STAFF RECOMMENDATION
1722 5th Avenue North
September 18, 2019

Application: New Construction—Addition; Partial Demolition
District: Salemtown Neighborhood Conservation Zoning Overlay
Council District: 19
Base Zoning: R6-A
Map and Parcel Number: 082051B00100
Applicant: Cheyenne Smith
Project Lead: Melissa Baldock, melissa.baldock@nashville.gov

<p>Description of Project: Application is to construct a rear addition and to alter window and porch openings.</p> <p>Recommendation Summary: Staff recommends approval with these conditions:</p> <ol style="list-style-type: none">1. Staff approve the design and material of the new front porch post;2. The connector between the existing side facing gables be reduced in width so that it is one foot (1') in from the existing wall of the back gable;3. The back gable not be extended in width;4. The new wall connecting the gables be designed to better reflect this area's history as a porch;5. The addition be inset one foot (1') from the back left corner; and6. Staff approve all windows and doors and the roof shingle color prior to purchase and installation. <p>With these conditions, staff finds that the proposed addition meets Sections III., IV., and

Figure 1. 1722 5th Avenue North

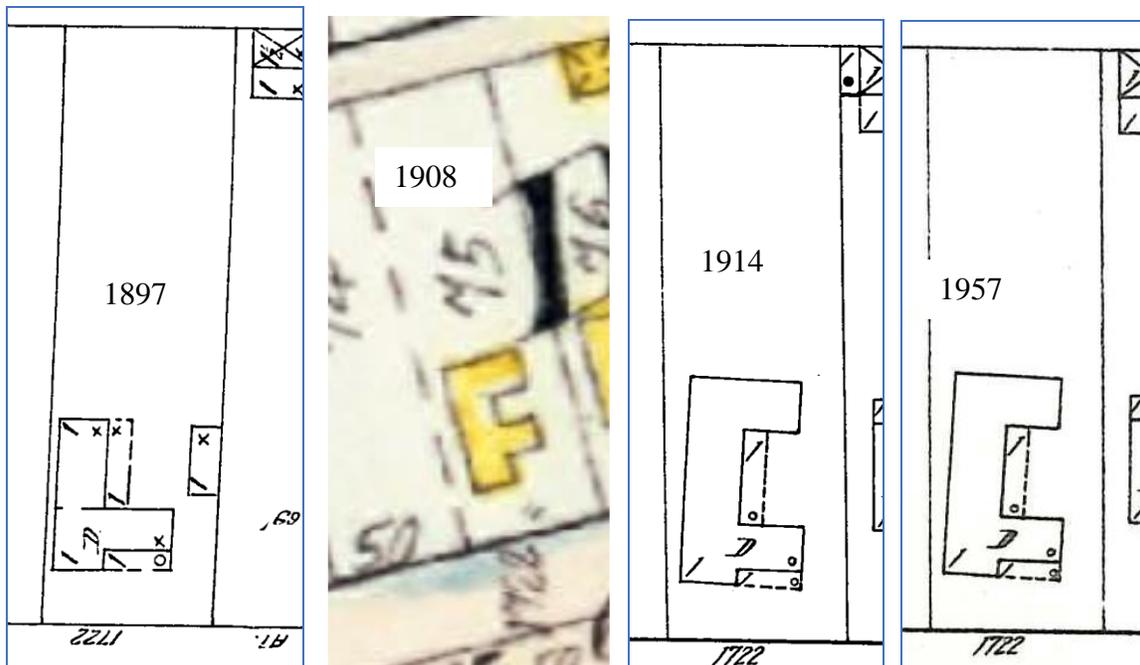
Background: 1722 5th Avenue North is a pre-1897 house that contributes to the historic character of the Salemtown Neighborhood Conservation Zoning Overlay (Figure 1). The house has experienced some changes over the last one hundred-plus years. Old maps show the evolution of the house's footprint. The back gable of the house does not appear on the c. 1897 map but does appear in a c. 1908 map (Figures 2, 3, 4, 5). Because this part of the house is so old, it is considered to be historic even if it is not original. The c. 1968 Property Assessor photo of the house shows that the windows on the front façade have been altered, and the existing siding is not historic (Figure 6). The design of the original porch columns is not known.

Figure 7. A 2019 aerial shows that the house's main form since 1908 remains intact. The shed roof at the rear is not historic and is non-contributing.

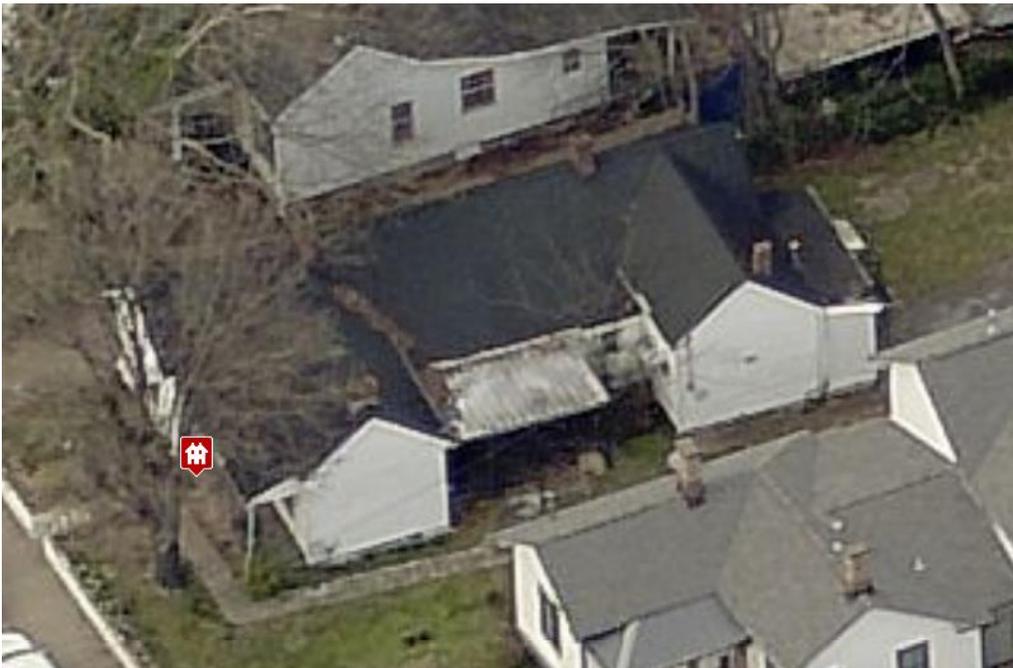
Demolition: The applicant proposes several changes that are considered partial demolition. First, at the rear, the applicant proposes to remove the rear shed roof portion of the house which was added after 1957 (Figure 8). Staff finds that this part of the house does not contribute to the house’s historic character and that its removal is appropriate.

Figure 10. The metal shed roof area will be removed.

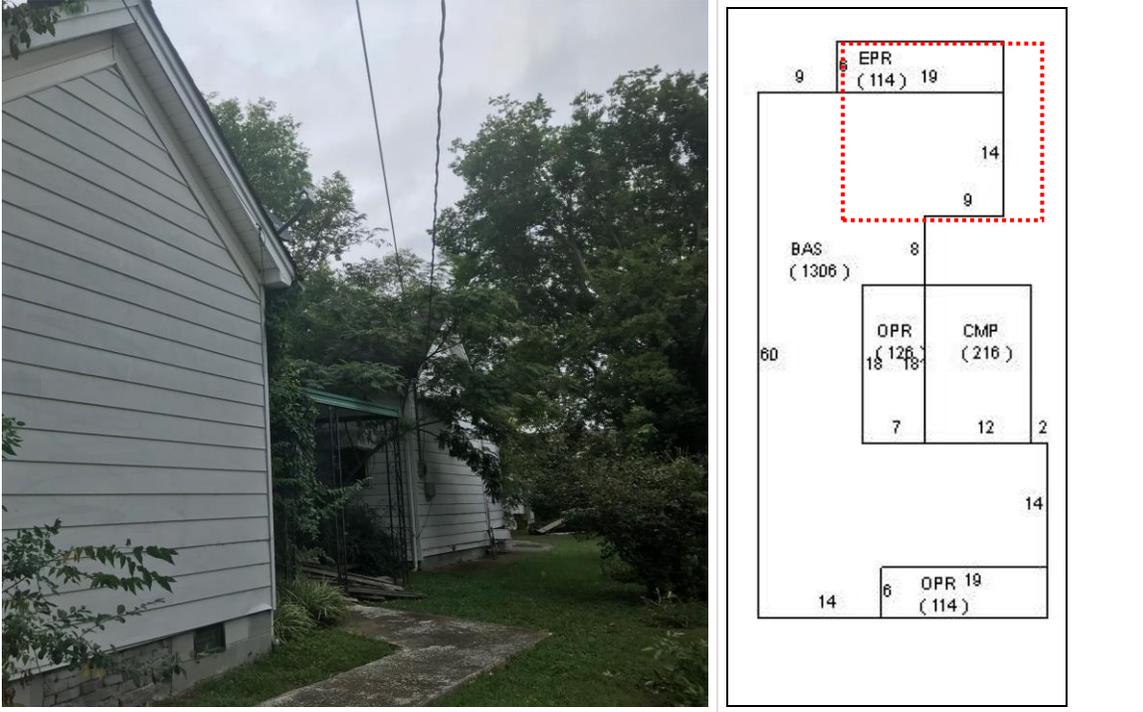
On the right façade, the applicant proposes to remove the non-contributing metal, shed roof structure and the existing porch posts and roof (Figures 10 & 11). The Sanborn maps show that this porch area is likely the same footprint as what is shown in the 1897 maps and later maps, although part of it has already been enclosed. However, the posts do not seem to be the original posts. Staff finds that altering this area some may be appropriate since the original porch is not highly visible from the street, so long as the new construction is appropriately inset from the two gable areas and the design of this part looks like a porch that has been enclosed.

With the conditions that the area tying the two side gables together is inset appropriately and designed to look like a porch that's been enclosed, and that the rear gable area not be extended to the side, staff finds that the proposed partial demolition meets Section V.B.2 for appropriate demolition and does not meet section V.B.1 for inappropriate demolition.

Figure 14. Staff’s suggested footprint for the addition in between the two side-facing gables.

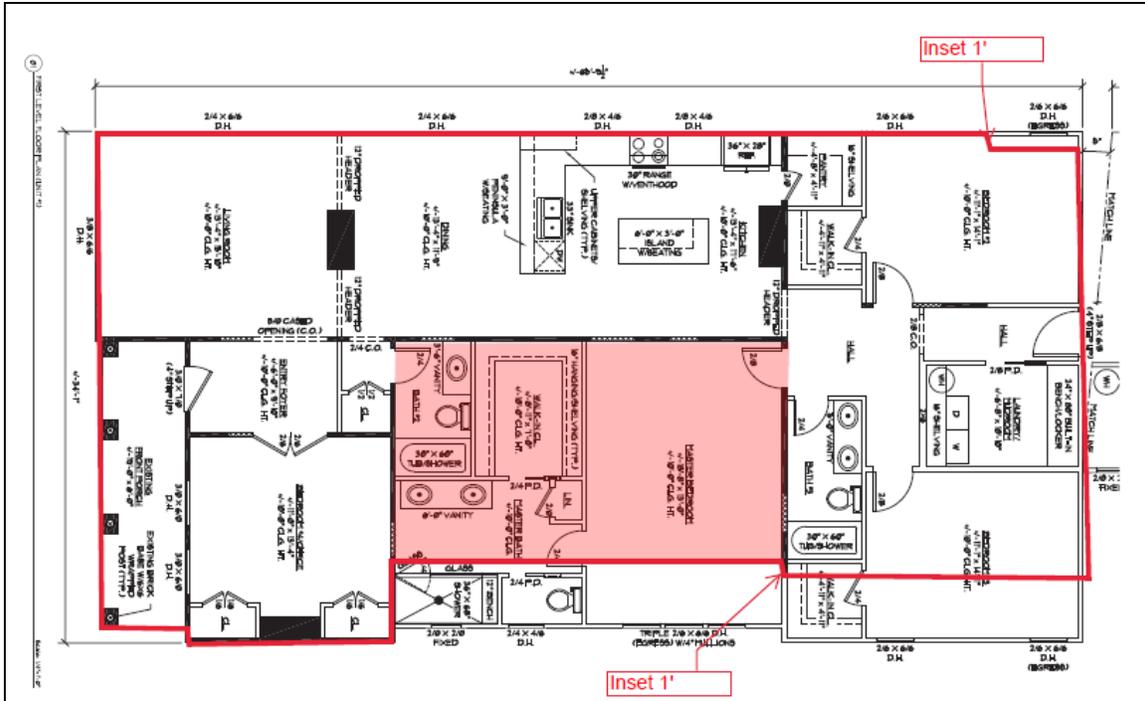
Height & Scale: The part of the addition that will be constructed between the two side-facing gables is one story in height and set a few inches below the roof ridge, which is appropriate. However, staff finds that its footprint and wall design are not appropriate for an area that was formerly a porch. In addition, staff finds that extending the rear side-gable form to be inappropriate, as it is altering an existing and historic roof form and footprint. Staff finds that filling in this area some could be appropriate since it is on a side elevation, with the condition that the new footprint be inset a minimum of one foot from the wall of the back side-facing gable (Figure 14). Staff also recommends that this wall be designed so that it looks like a porch that has been enclosed. On the left side of the house, the applicant is extending the footprint of the existing rear extension across the entire back of the house. While extending the footprint is appropriate, staff recommends that the back corner of the house remain with a one foot inset (See Figure 14).

With the conditions that the connector between the existing side facing gables be reduced in width so that it is one foot (1’) in from the existing wall of the back gable, the back gable not be extended in width, the new wall connecting the gables be designed to better reflect this area’s history as a porch, and the addition be inset one foot (1’) from the back left corner, staff finds that the addition’s height and scale to meet Sections III.A., III.B. and IV of the design guidelines.
